TECHNICAL DRAINAGE STUDY RESPONSE TO COMMENTS

TROPICAL PKWY/CENTENNIAL PKWY ROADWAY IMPROVEMENTS

Re: **Technical Drainage Study for Tropical Pkwy./Centennial Pkwy. Roadway
Improvements
CNLV No. 43988**

The purpose of this letter is to address comments contained in the November 30, 2011 review memorandum prepared for the above referenced project. The comments are addressed as follows:

Decatur Blvd Q10 EX Sec C

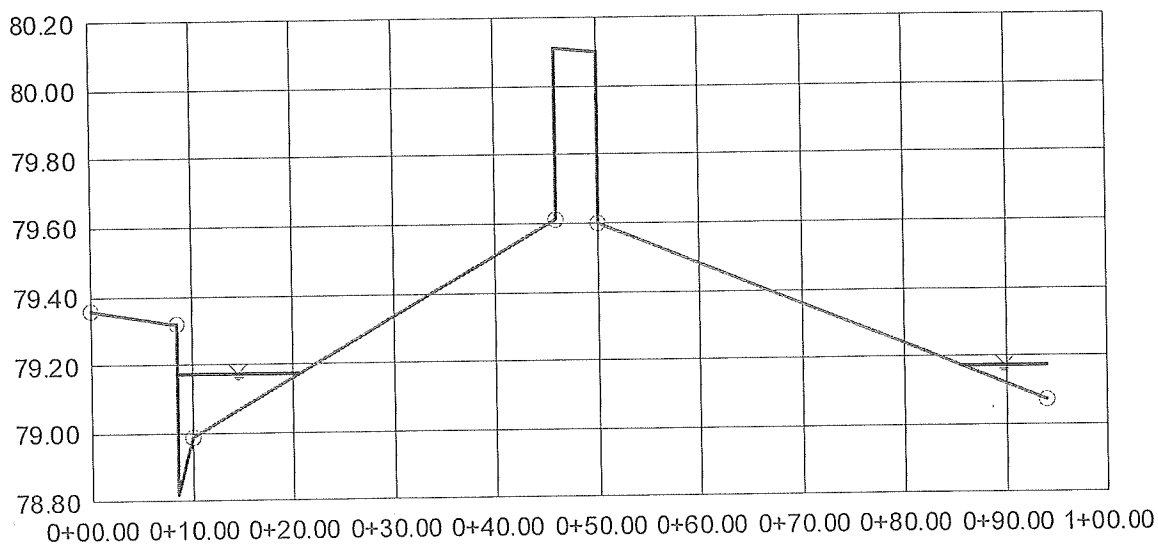
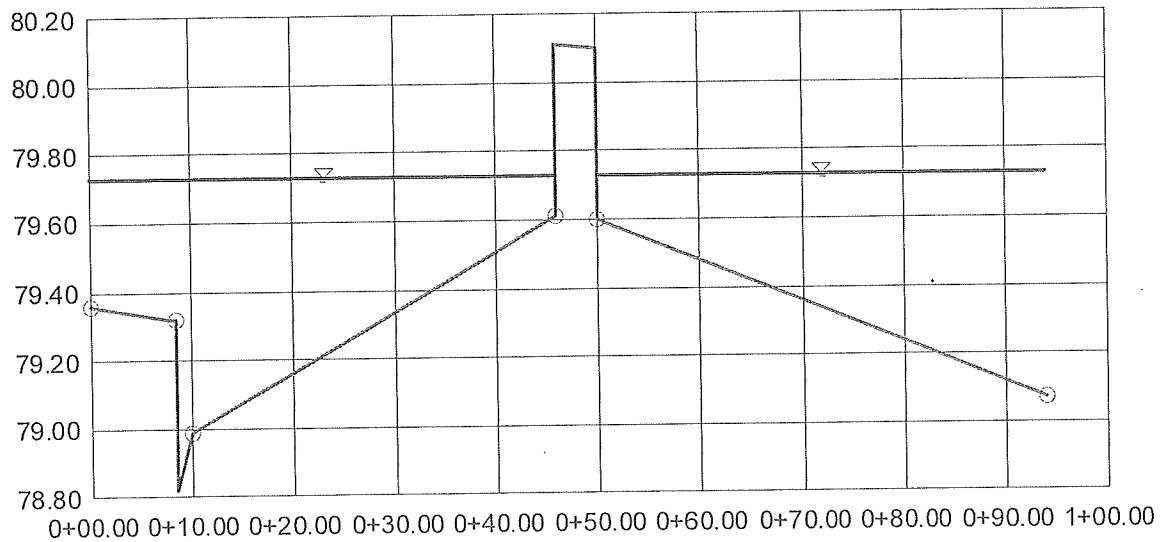
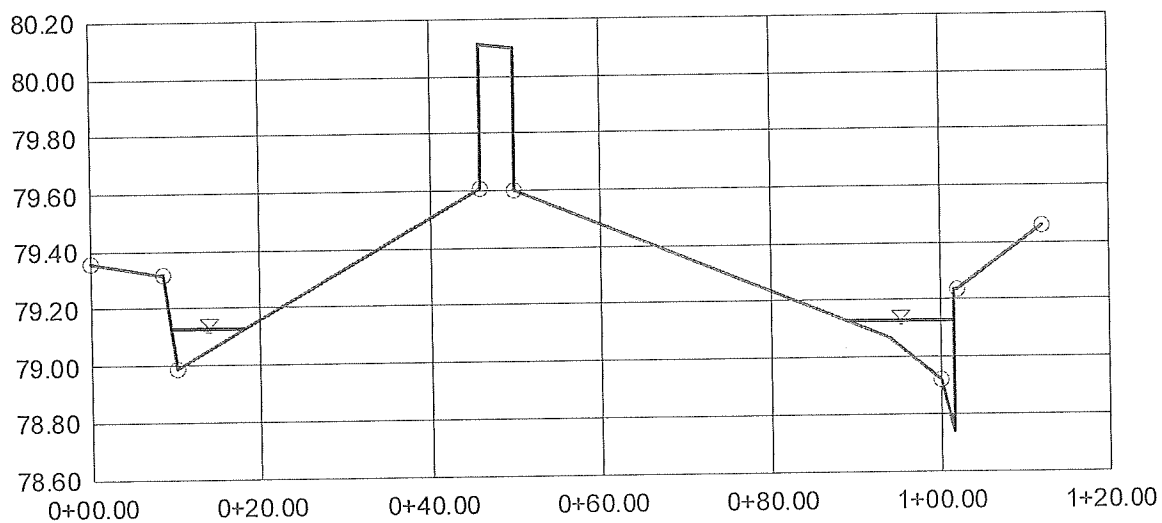
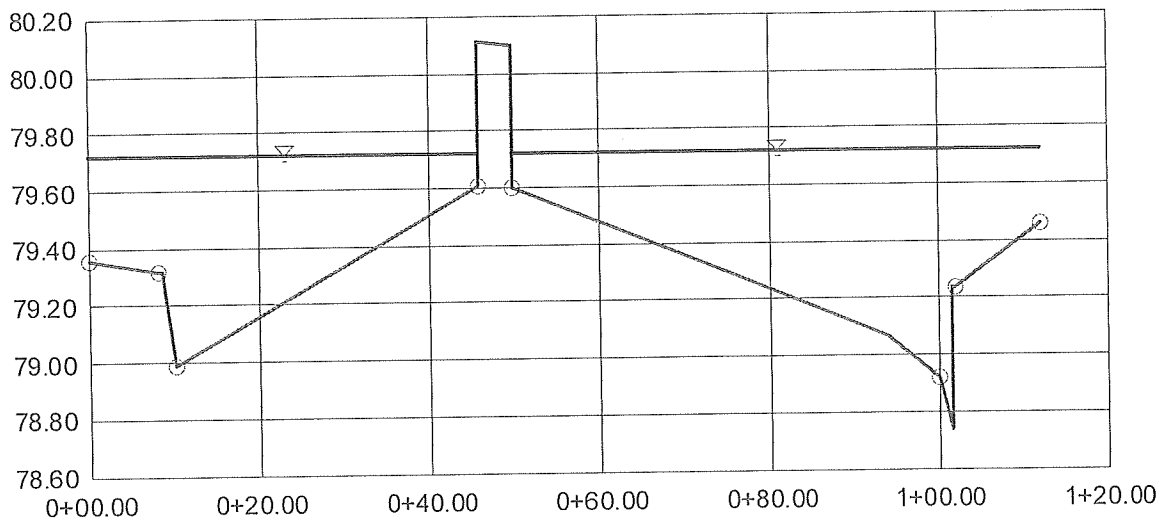
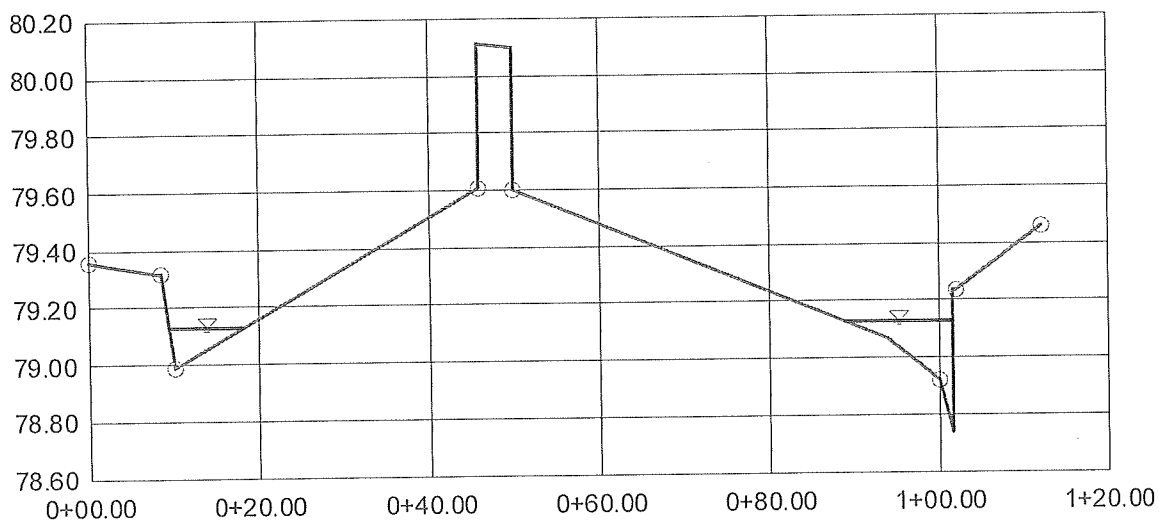
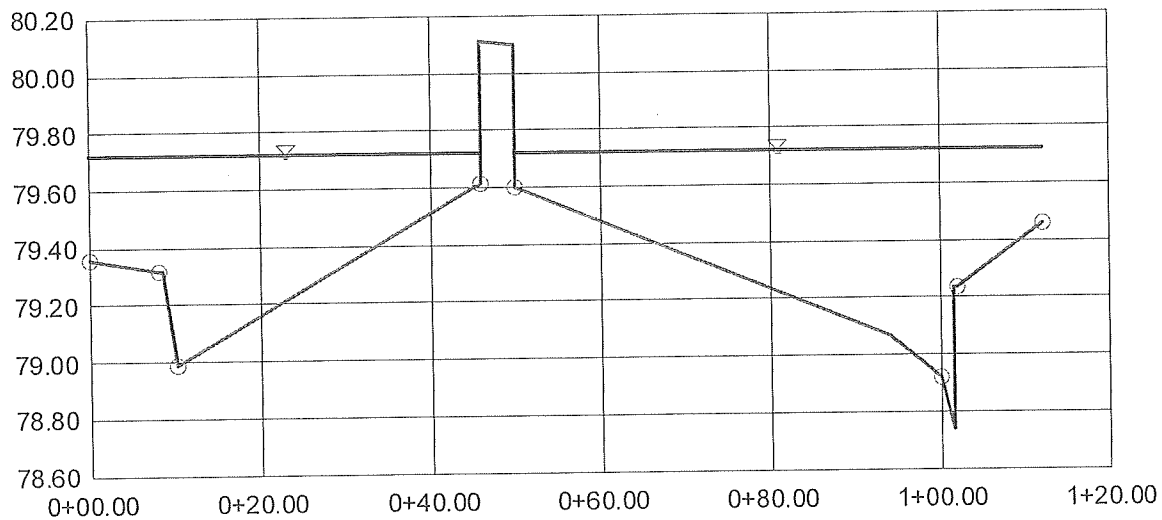
3. **Comment:** *A quick review of the general topography in the area shows that the area surrounding the project site drains southeasterly direction. It appears that Decatur Boulevard, adjacent to the site, may intercept some offsite flows from upstream of the project site.*

Section 1.5 of TDS states that "Improvements west of Decatur have effectively cut off flows and routed them into the existing storm drain in Decatur." Please provide approved reference materials to illustrate that all flows are being contained within the existing storm drain in Decatur Boulevard. Please note that all 10-year and 100-year street capacity calculations must be revised to reflect any flow changes. Also, 12' dry lane criterion must also be met for the future condition.

Response: Based on reference studies provided by the City of Las Vegas for Winco Las Vegas (Thienes Engineering, 2011) which was an Update to the TDS for Decatur/215 (Southwest Engineering, 2008) there is an existing surface flow (section G in reference files) south in Decatur Blvd of 9 cfs during the 10-year storm event and 155 cfs during the 100-year storm event at the intersection of Decatur and Tropical, this flow proceeds remains in the Decatur right-of-way and heads south. At the Rice and Decatur intersection there is a surface flow of 0 cfs and 138 cfs during the 100-year storm event (Section E in the reference files). The existing 54" storm drain conveys 86 cfs. The street flow calculations show that the 10-year dry lane criteria is met. The 100-year storm event will produce a depth of flow 0.98 ft deep. The velocities however are non-erosive. Any developments proposed to front on Decatur Blvd will provide flood protection to prevent flood water from inundating the property. Any future on-site developments will address this issue within their technical study. Copies of the reference material documenting these surface flows are included in Appendix A. All relevant Figures and calculations have been revised and included in the appendix. Based on review of the reference material it states that the storm water flow in Decatur Blvd will continue south and will not be picked up by any future storm drain. The downstream properties appear to have been designed to accommodate this storm water flow.
